PARRAMATTA POWERHOUSE (SSD-10416)

**Submission to Applicant's 'Response to
Submissions' made on behalf of the
landowners of 32 Phillip Street, Parramatta**

Figure 10 – Site Plan – Civic Link

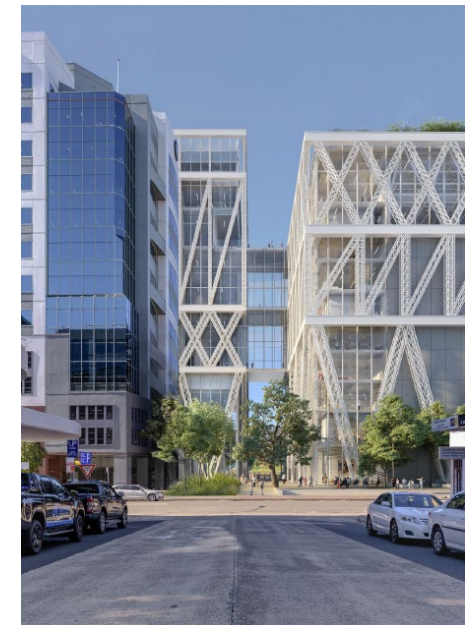
Despite widening of the Civic Link as a result of changes to PPM building envelopes, the PPM RTS seeks to provide continuous landscaping to the western frontage of the Civic Link, surrounding the boundary of 32 Phillip Street.

Aligned to the original submission, concern is raised of the capacity for this design approach to provide an integrated precinct whereby the PPM design demonstrate the following principles:

1a) The PPM project team should be requested to refine the proposed landscape treatment for the Civic Link and meet with Australian Unity to discuss appropriate landscape treatment adjoining the boundary with 32 Phillip Street

1b) The landscape treatment on the western side of the Civic Link should allow for ground level use of the 32 Phillip Street site (existing and future) to include active uses that address and make the most positive contribution to activating the Civic Link.

1c) The landscape treatment of the Civic Link should be open to allow pedestrian movement and visual connections between buildings on both sides of the Civic Link.

1d) The landscape solution for the PPM should provide for outdoor dining opportunities including licenced areas along the western edge of the Civic Link fronting the 32 Phillip Street site.

Figure 1: Stormwater Catchments and Pipes

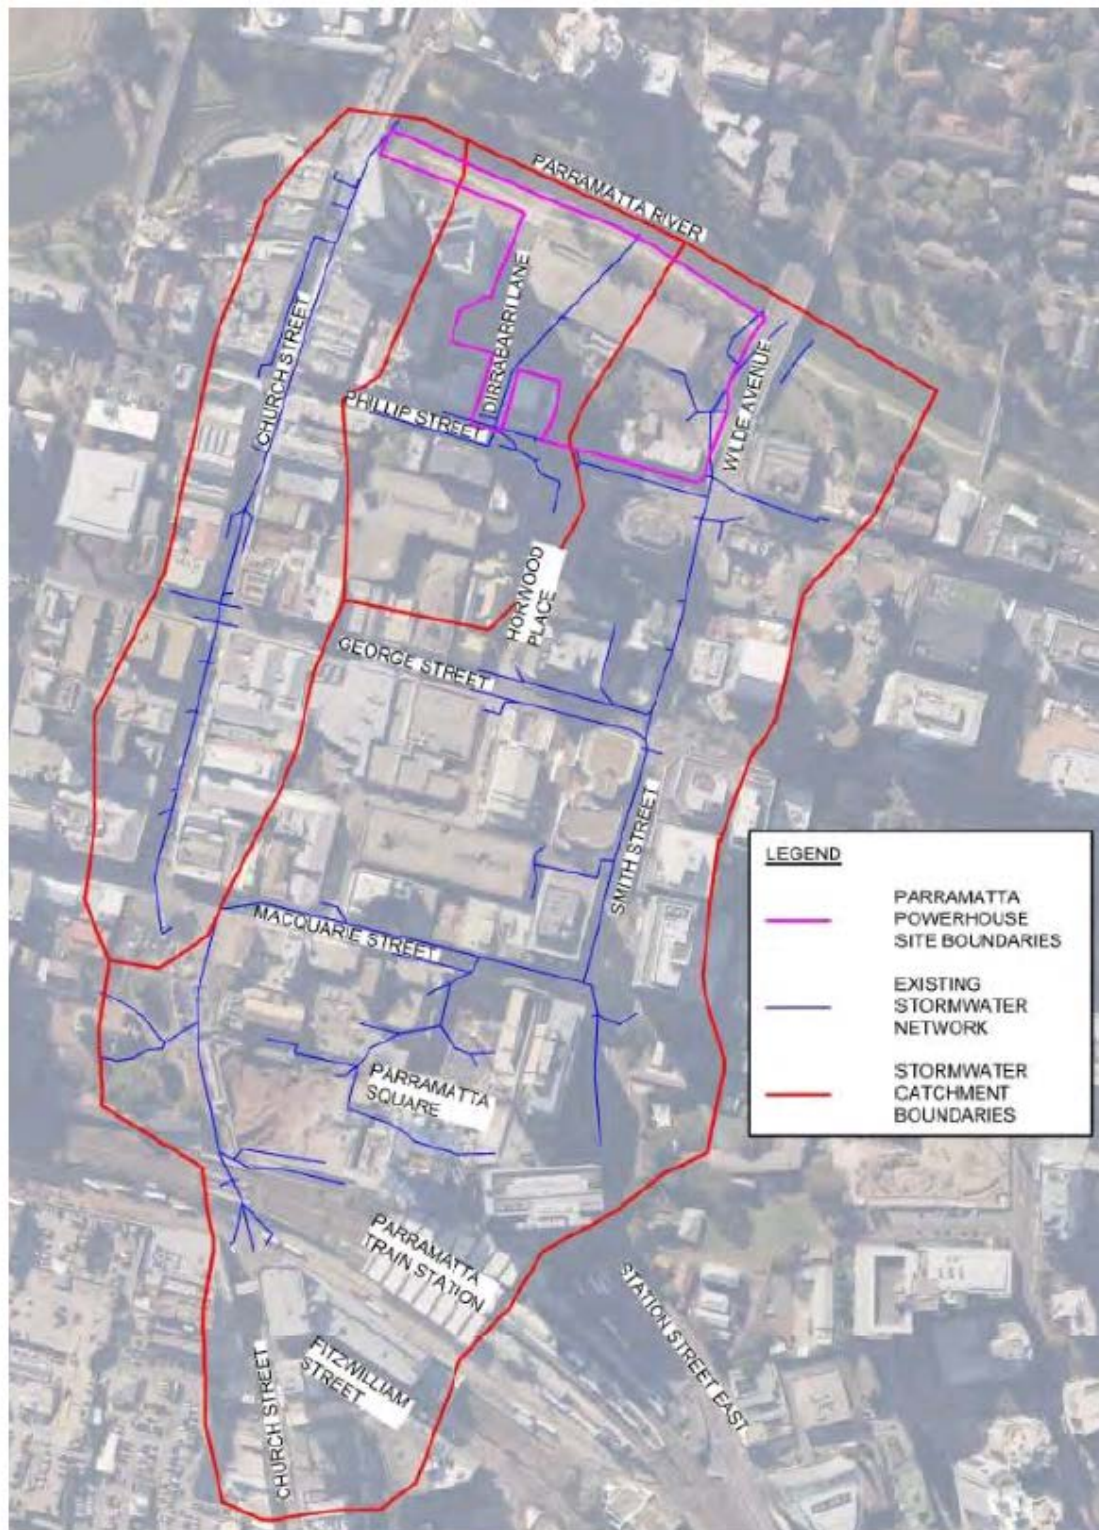
Figure 20 from Appendix O of the EIS (reproduced on the next page as Figure 1) shows the stormwater drainage catchments and underground pipe network which drain through the museum site to the River. The smaller, middle catchment includes 32 Phillip Street which is a noticeable indent in the southern boundary of the museum site.

The figure also shows there is drainage in Horwood Place and on both sides of Phillip Street which feed into a 600mm diameter pipe which runs along Dirrabarri Lane before cutting through the at-grade car park at the rear of 32 Phillip and under the multideck carpark before discharging into the Parramatta River.

Figure 2: 5% AEP Flood Levels and Depths

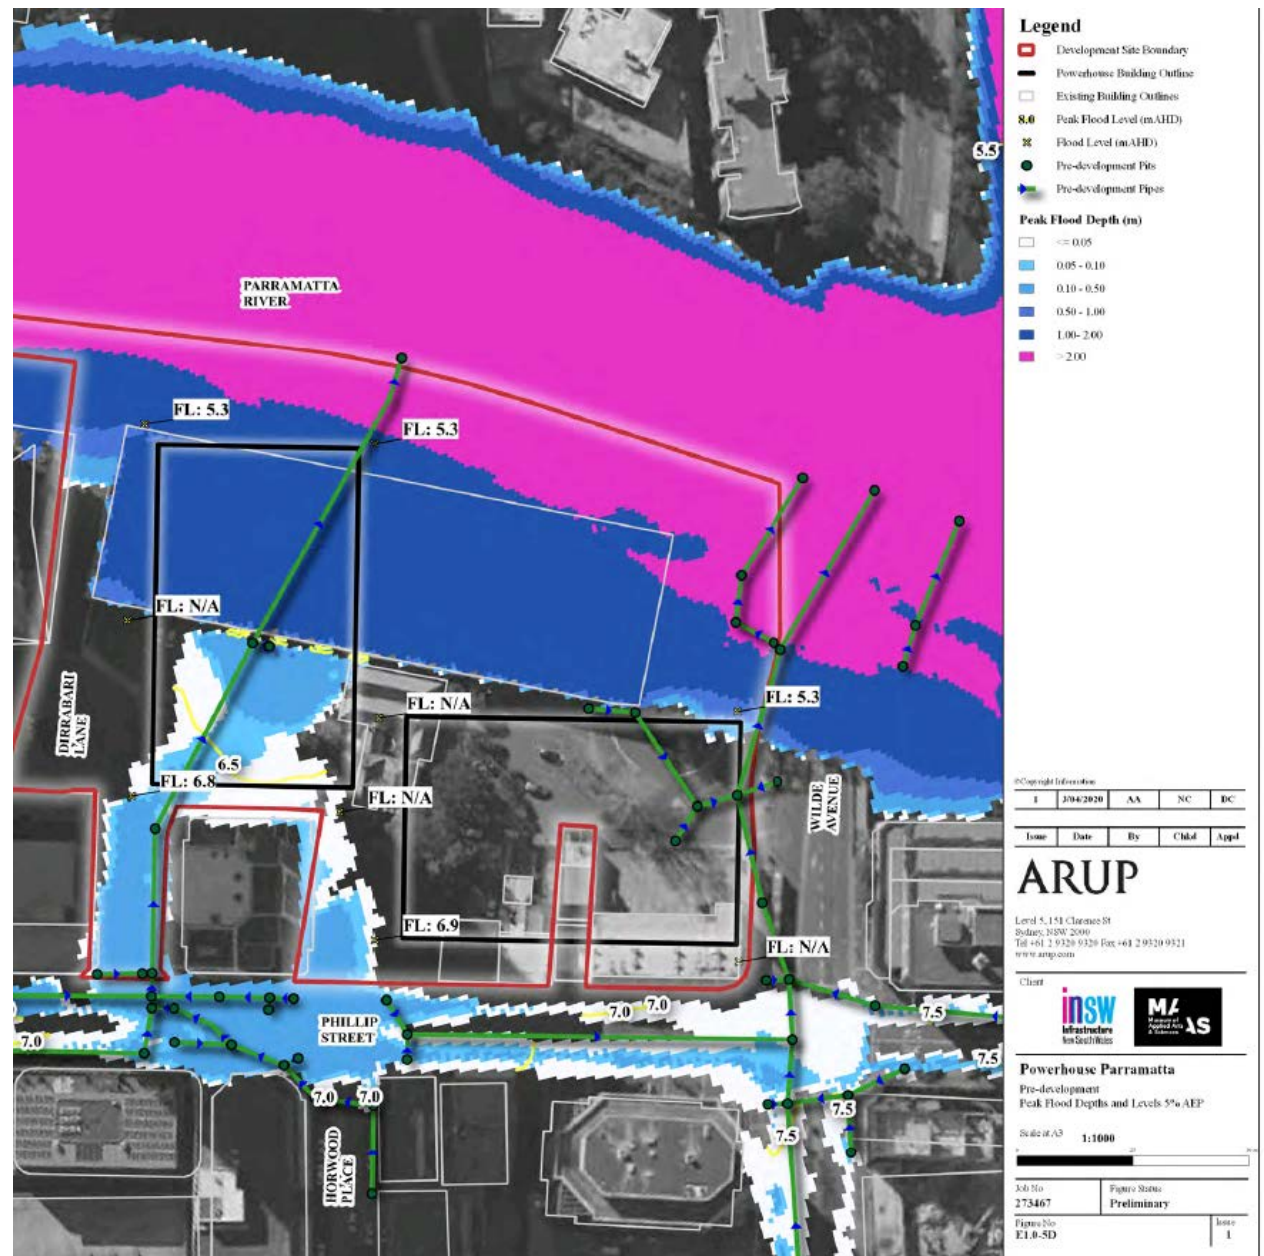
Figure 2 shows that even in a 5% AEP overland flow event the underground pipe network is unable to take all of the flows. Because Dirrabarri Lane and Willow Grove are slightly higher than Phillip St, the water ponds in Phillip St. Once it has reached sufficient depth it flows around either side of 32 Phillip Street and into the at-grade car park at its rear. This is what happened on 9th February, 2020 and floodwaters entered the foyer of 32 Phillip Street.

It could be ponding up to 0.5m deep at the front of the building in a 5% AEP event. In the 1% AEP flood the water depths in front of 32 Phillip Street would be a little deeper. In the PMF the water could be up to 4.5m deep in front of 32 Phillip Street but this would be mainly controlled by the flood level in the Parramatta River which would only be about half a metre lower.

Figure 3: Proposed Design Responses to Manage Overland Flows

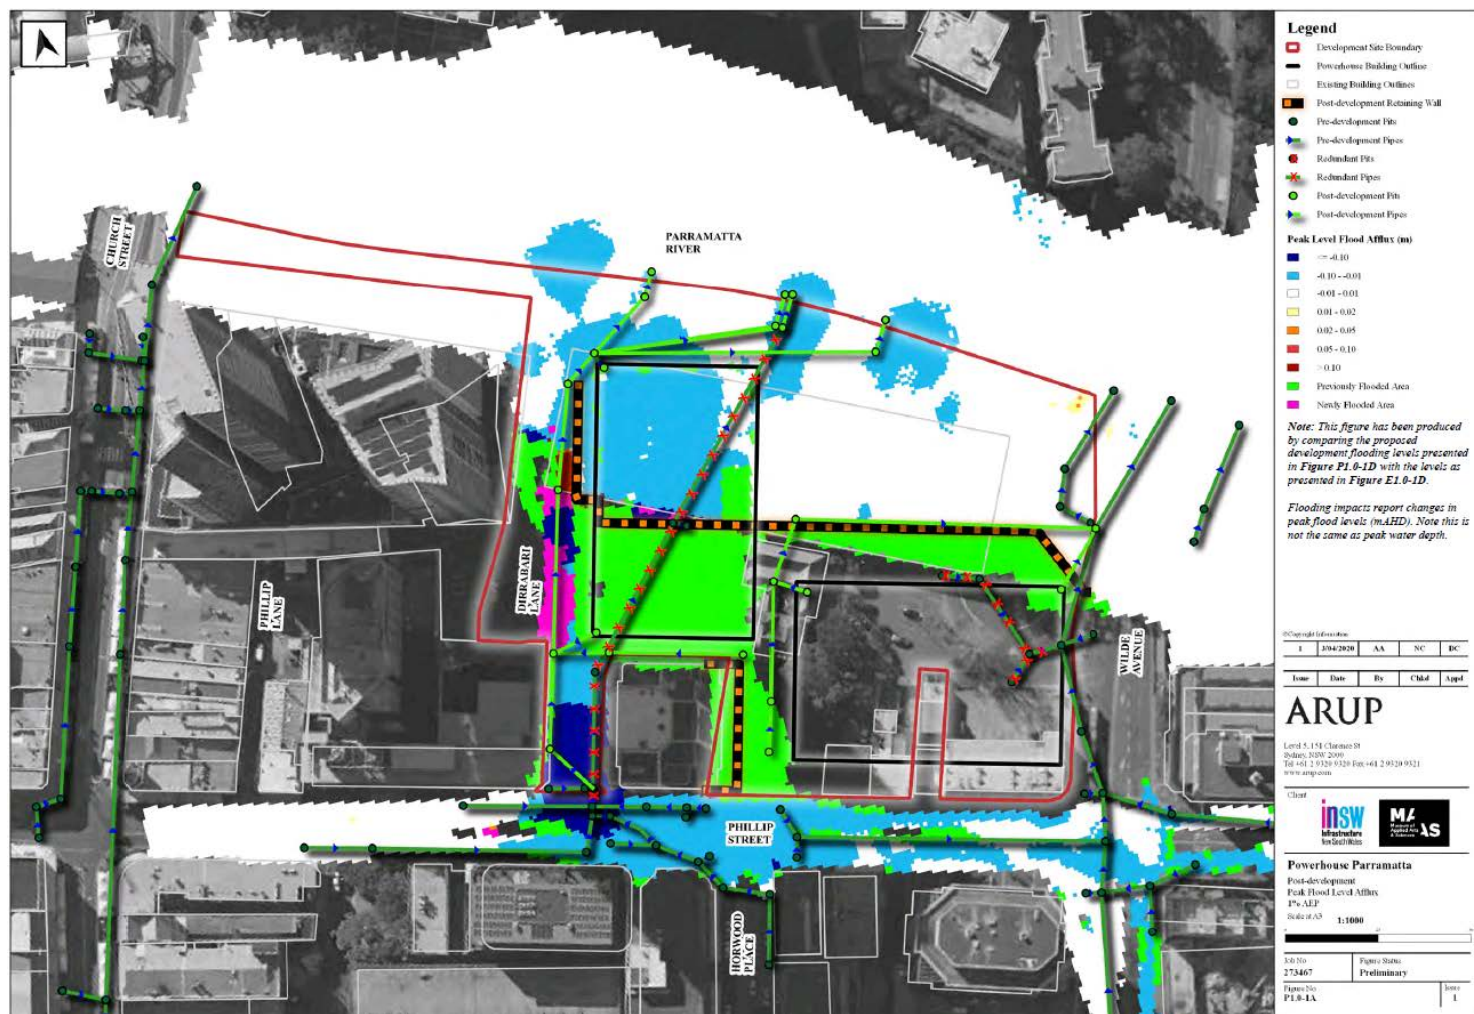
Figure 3 shows how the museum development proposes to manage overland flows and the impacts on overland flows in a 1% AEP event.. The existing 600mm diameter pipe which currently runs under Dirrabarri Lane and the multideck carpark will be replaced by a 1200mm diameter pipe running under Dirrabarri Lane and heading directly north to the river. Then on the eastern side of 32 Phillip Street a new 600mm pipe will be laid to take water directly to the river between the two museum buildings.

As can be seen in Figure 3, these measures would eliminate flooding to the immediate east and north of 32 Phillip Street and slightly reduce levels in Phillip Street and Dirrabarri Lane in a 1% AEP event.

Furthermore, the overland flow management strategy within the Powerhouse Museum design is to increase the capacity of the pipe in Dirrabirra Lane and to provide a new pipe to take

overland flows along the eastern side of 32 Phillip Street. This will effectively increase the flow rate underground and reduce the flow rate overland. However, if the inlets to the pipes are 100% blocked then they will make no contribution to flood conveyance and will not reduce flood levels at 32 Phillip Street. In fact, if the level of Dirrabirra Lane is proposed to be raised, and it is certainly proposed to increase the ground levels to the east of 32 Phillip Street, then the water will need to pond to a higher level in Phillip Street and increase the flood levels for 32 Phillip Street.

- the provision of amplified stormwater pipes on either side of 32 Phillip Street be supported
- the flood impacts of the final museum design be tested using Council's more up to date, and peer reviewed, flood model when it becomes available (probably late 2020) to ensure that there will be no adverse flood impacts on 32 Phillip Street or the public spaces immediately surrounding it.
- when the detailed design and updated flood modelling is undertaken that the design solution be one which does not increase flood levels adjacent to 32 Phillip Street and is unlikely to do so even were there to be 100% inlet or pipe blockage.
